ProtoDUNE SiPM Signal Processor

DESIGN IMPROVEMENT PLANS

<OrgName>		
Title Design Improvements		
Size	Document Number	Rev <RevCode>
B	<Doc>	
Date:	Sheet	of
Wednesday, May 17, 2017	1	1

U1 DSP FPGA

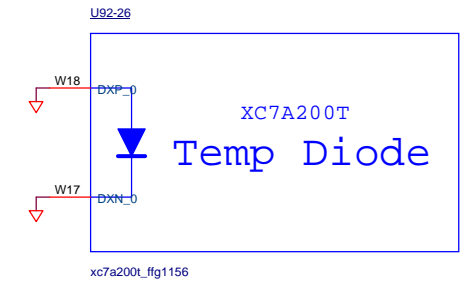
DIP #1) Unused pins GTP blocks of Artix-7 FPGA not tied to ground as recommended.

Rear Panel RJ45 Connectors to Channels 0 to 11

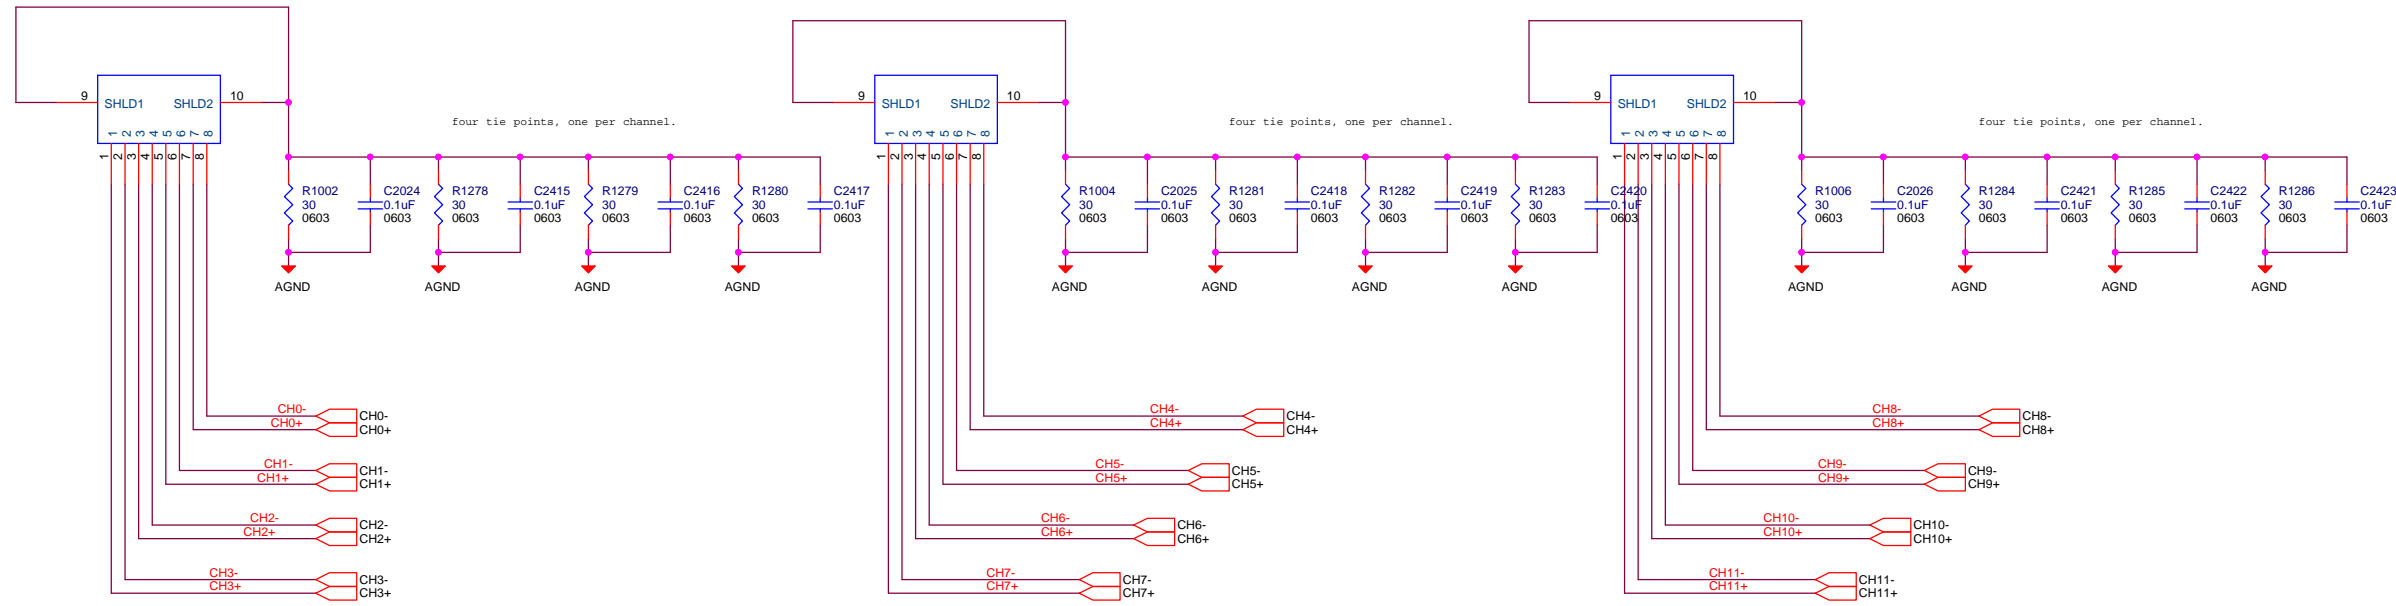
Layout issue not addressed in prototype ECOs
 Polarity of RJ45 pairs swapped relative to expectations. + and - of each channel swapped here by flipping the ports in pairs relative to the prototype and as-built.

SFP interface to timing system

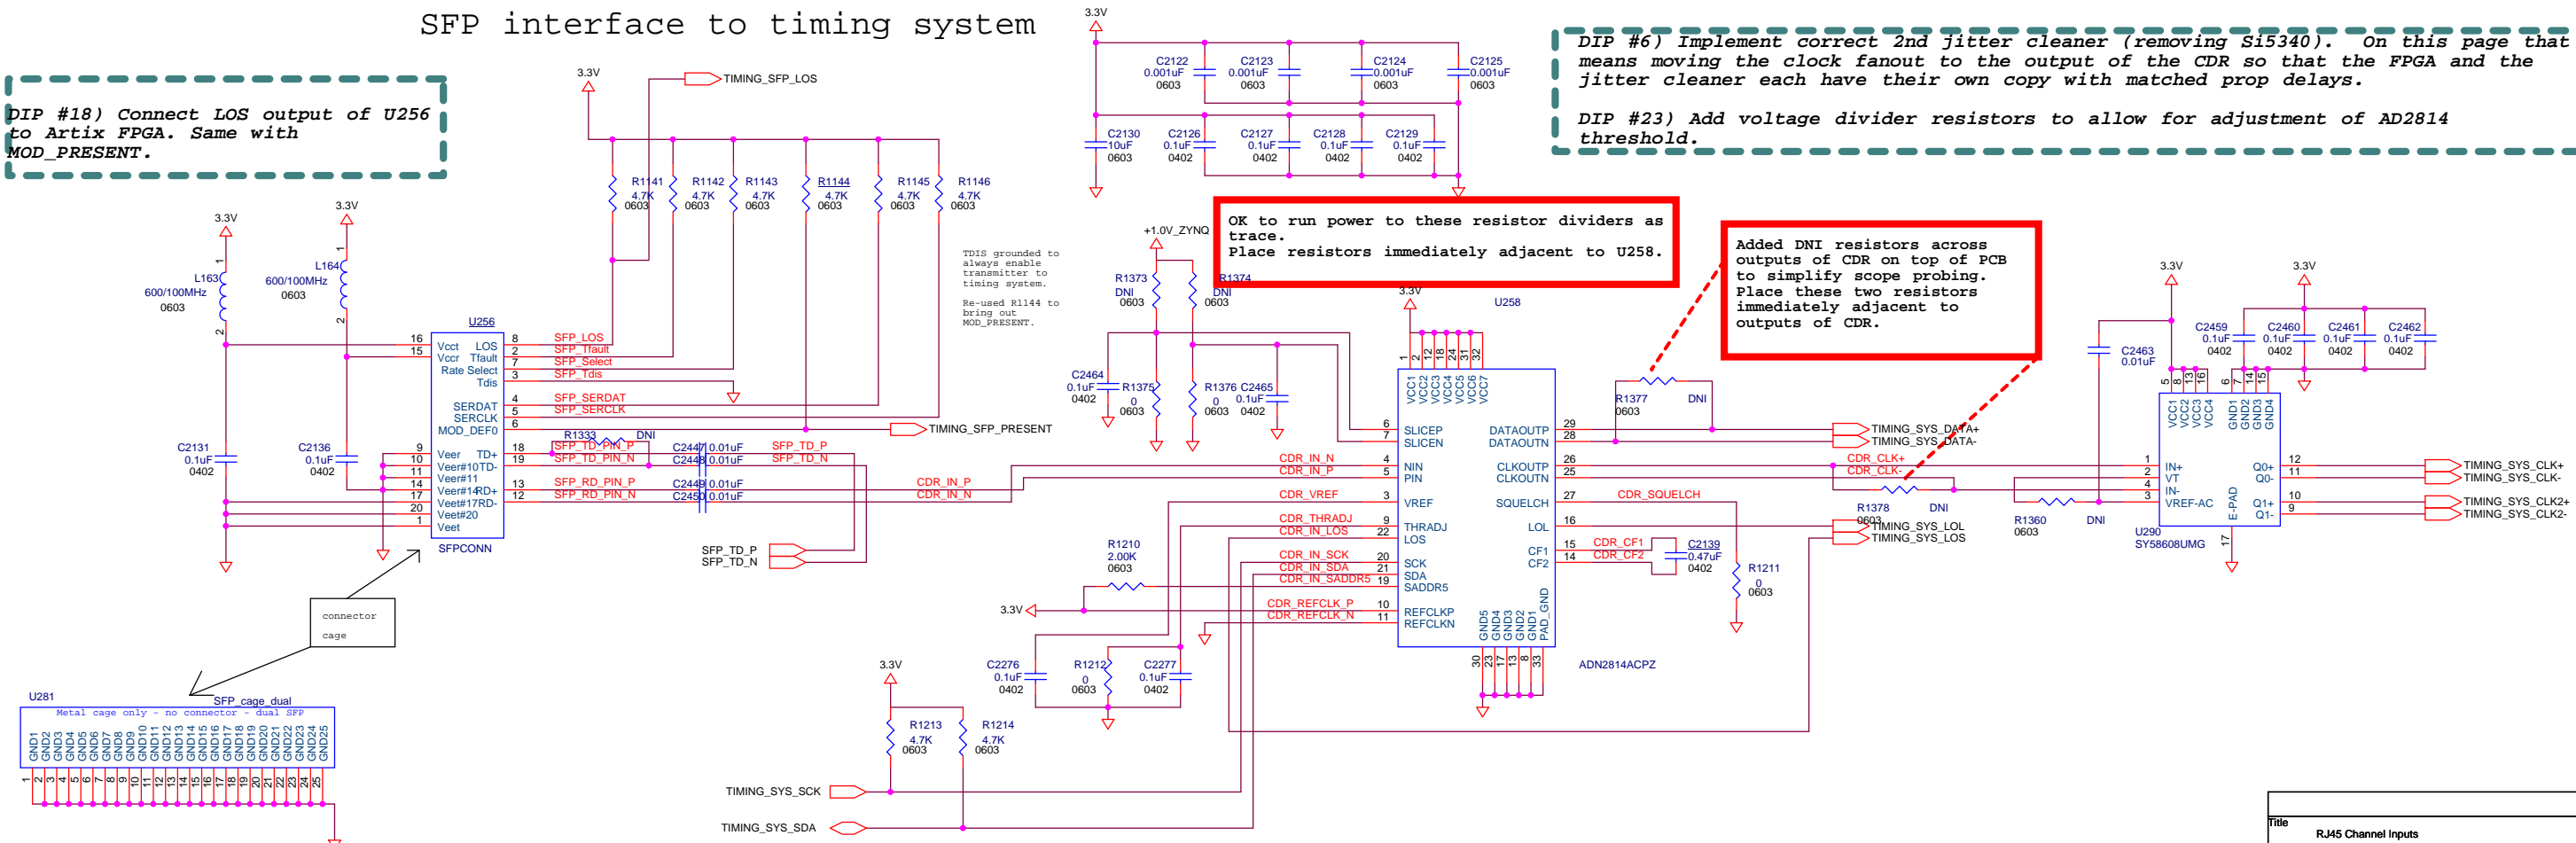
DIP #18) Connect LOS output of U256 to Artix FPGA. Same with MOD_PRESENT.

DIP #6) Implement correct 2nd jitter cleaner (removing Si5340). On this page that means moving the clock fanout to the output of the CDR so that the FPGA and the jitter cleaner each have their own copy with matched prop delays.

DIP #23) Add voltage divider resistors to allow for adjustment of AD2814 threshold.

OK to run power to these resistor dividers as trace. Place resistors immediately adjacent to U258.

Added DNI resistors across outputs of CDR on top of PCB to simplify scope probing. Place these two resistors immediately adjacent to outputs of CDR.

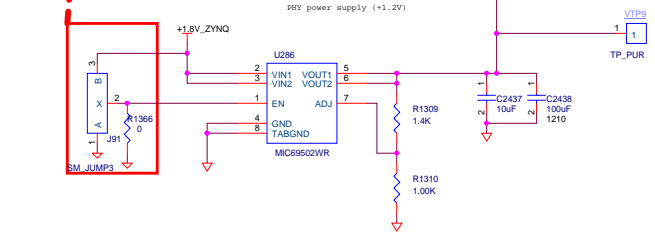
DIP #2) Add SM jumpers to power supplies of Zynq section so that at initial power application regulators are disabled. ANL staff will then move the 0 ohm resistors of the jumpers to the Enable position (X-B) during post-assembly testing.

Place 0 ohm resistors on top of SM_JUMP3 components so that only pads of SM_JUMP3 are seen.
When assembled 0 ohm resistors shall be soldered onto A-X or X-B position of jumper as shown.
